LISMORE BASE HOSPITAL
NEW PSYCHIATRIC UNIT PROJECT
PREFERRED PROJECT REPORT
And
STATEMENT OF COMMITMENTS

Prepared for
NSW Health
and
North Coast Area Health Service

1 December 2006

Revision 05

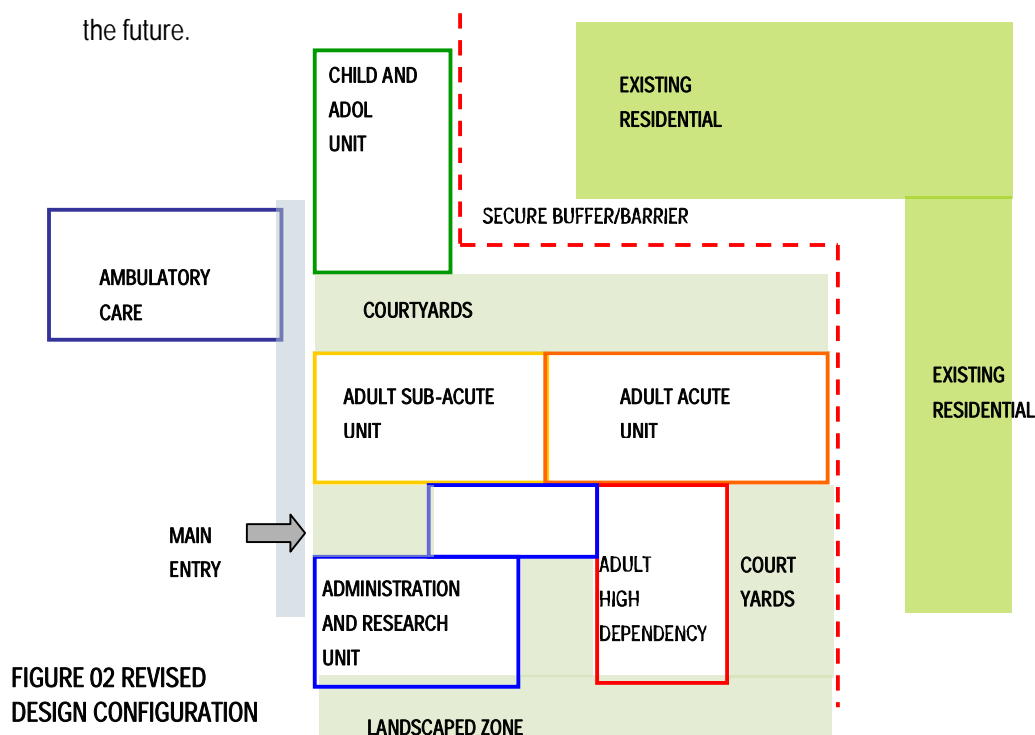
In addressing the concerns raised by the community, in relation to safety and security issues, the revised configuration has relocated the 8 bed Adult High Dependency unit further west of the site and away from the existing residential developments, see Figure 02 below. This has established the following benefits:

1. With the Hight Dependency Unit (HDU) relocated further west of the Little Uralba Street boundary, the patients requiring the highest observation, containment and clinical intervention are located furthest away form the residential areas, therefore further improving the facility's security.

2. The revised configuration of the HDU will facilitate better patient transport to and from the main Hospital Complex, again this will facilitate better patient management, further reinforcing security and safety.

3. The revised location of the HDU and the rationalisation of the overall planning of the Adult mental health unit, will establish a smaller foot print for the overall facility and allow additional areas for landscaped courtyards, therefore reducing the visual impact of the redevelopment.

4. The revised planning has also relocated the ambulance and police patient drop-off area for the adult inpatient units from an open secure compound on the corner of Weaver St and Fermoy Ave to within the underground parking facility in a secured facility with direct access to the lift system. This will further improve the function of patient delivery to and from the new unit by police or ambulance.

5. The additional open site area created by the smaller footprint of the facility will support the future master planning of the Hospital site and allow a greater degree of flexibility in developing the psychiatric unit in the future.

FIGURE 03 STAGE 1 NEW PSYCHIATRIC FACILITY REVISED MASTER PLANNING LEVEL 1

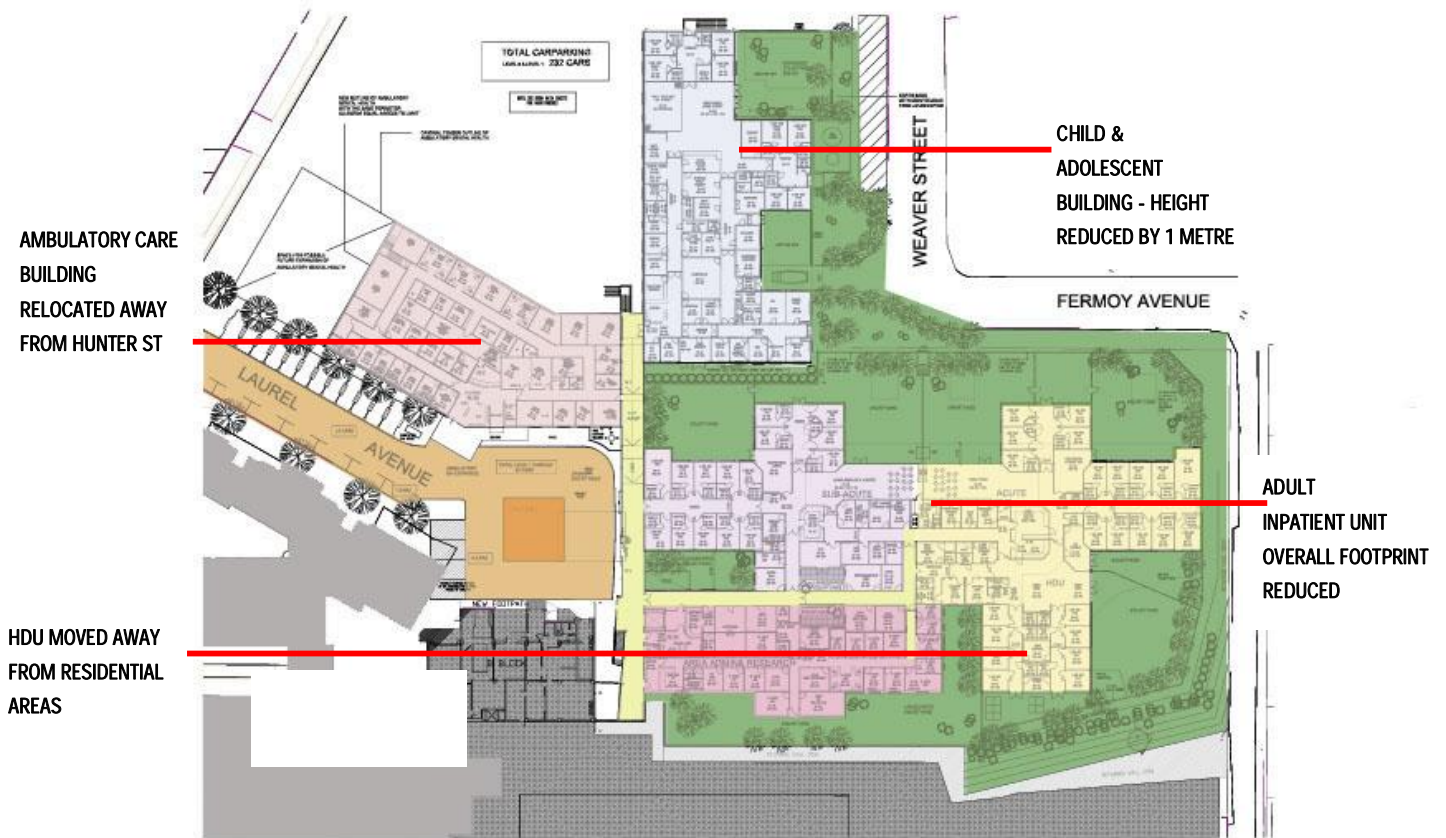
Below is the revised facility master plan, it should be noted that the overall site strategy has been maintained which will support and enhance the future master plan stages of Lismore Base Hospital.

Drawing Title
**PLANS / ELEVATIONS /
 SECTIONS
 ENTRANCE LINK AREA**

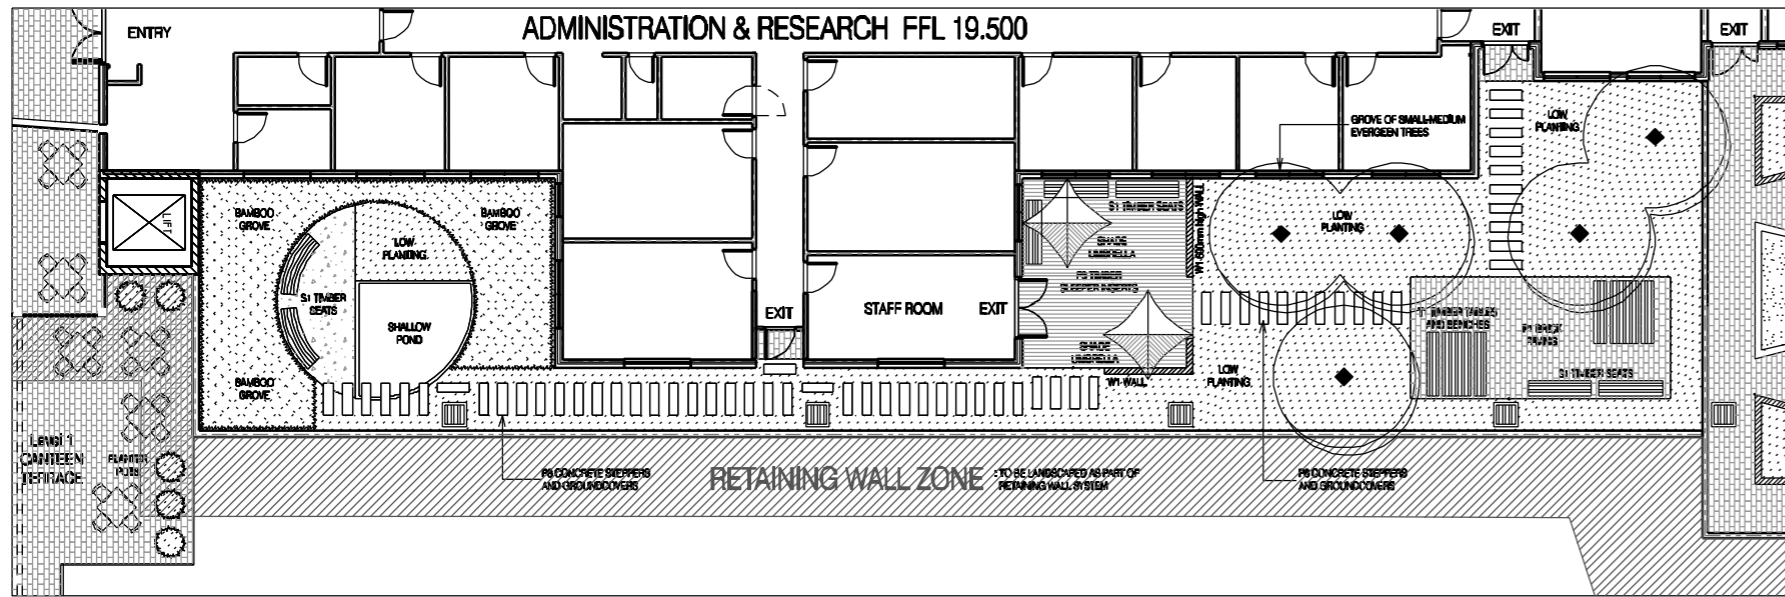
<p>Transport and Access</p> <p>The RTA is of the view that the Traffic Impact Study is inadequate to assess the effect of the proposal on the operation on the surrounding road network and infrastructure. This will need to be resolved with the RTA before the Department can finalise its assessment and make a recommendation to the Minister.</p> <p>Further detailed plans and documentation should be provided which better articulates how the three storey pedestrian link from the existing hospital building (Block A) into the new health facility will function.</p>	<p>A traffic study has been undertaken by a qualified traffic consultant, the result of which has been incorporated into the design of the new facility and formed part of the EA issued to NSW Planning.</p> <p>The Traffic Study was issued to the RTA for review. The RTA has confirmed verbally that traffic study adequately assesses the impact of traffic generated by the development. and therefore the RTA supports the redevelopment application</p> <p>Refer to plans in Appendix 4 in relation to the three storey link to Block A Drawing A501.</p>

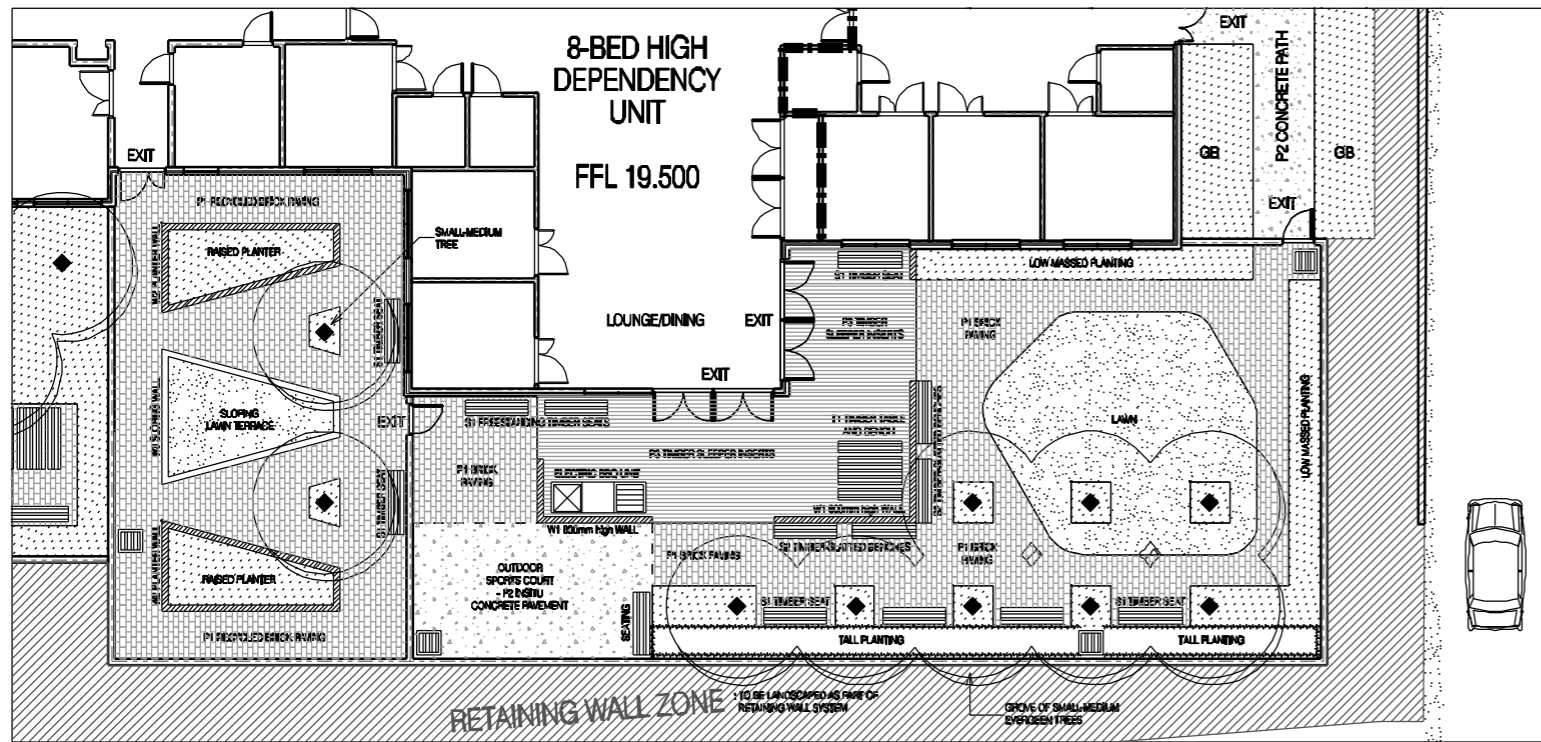
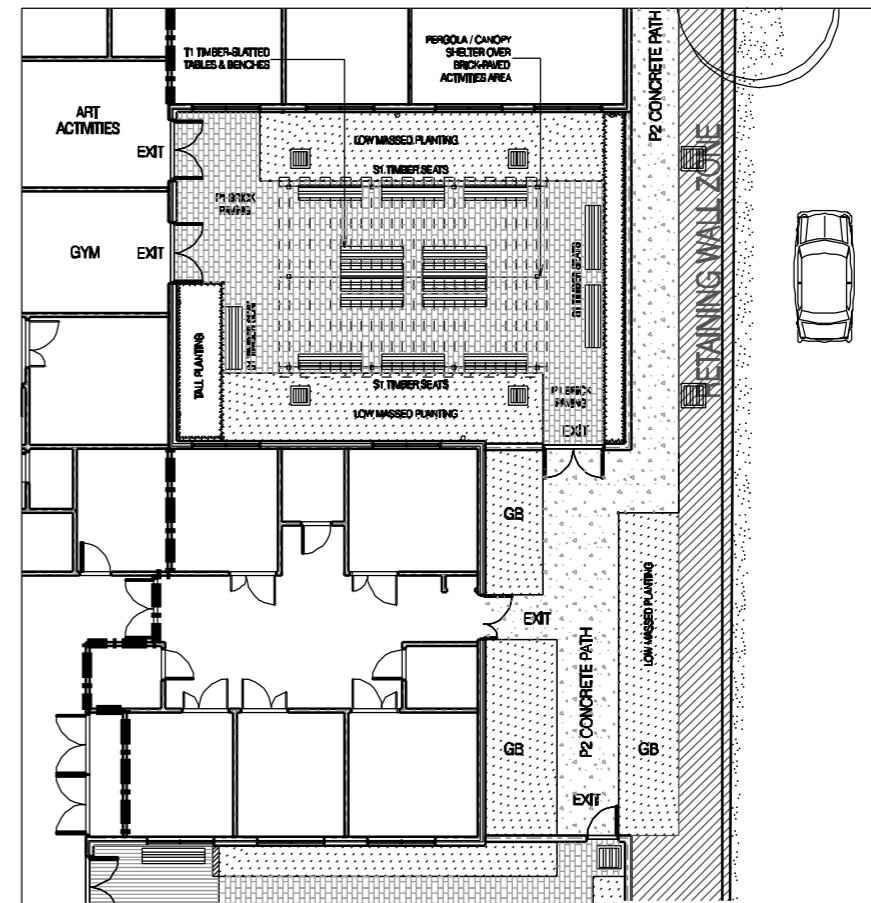
<p>Landscaping</p> <p>One minor point. Plan 7455 L003 refers to "Landscaping Courtyard Detailed Plans (1 of 2)". Is there a "2 of 2" or is this a typo?</p>	<p>Drawing 2 of 2 is further detail of the courtyard landscaping, a copy has been included in the report for information. Refer to Appendix 4</p>
